**TB 0459**

**Product Group:** Manual Wheelchairs

**Model Affected:** Quickie Life Folding

**Bulletin Subject:** Improvement to cross brace

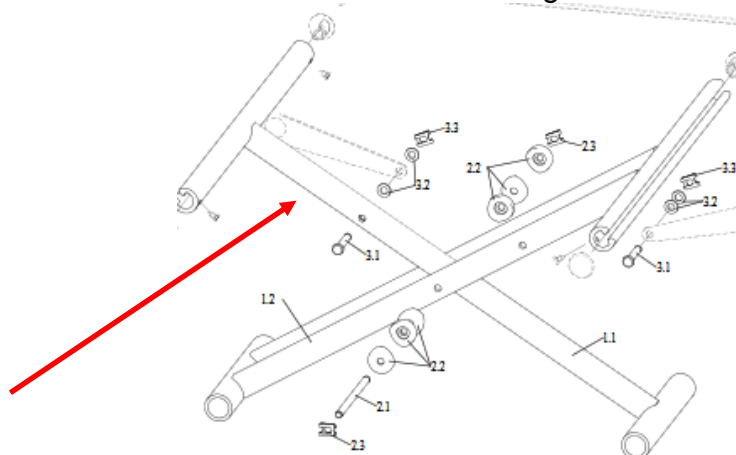
A number of Life folding chairs in the field would not unfold correctly - the seat rails would not slide into the receivers.

The new cross brace has an increased diameter, moving from 23mm to 25mm for the single tube, and reduced tolerances for the central bolt to remove the folding issues
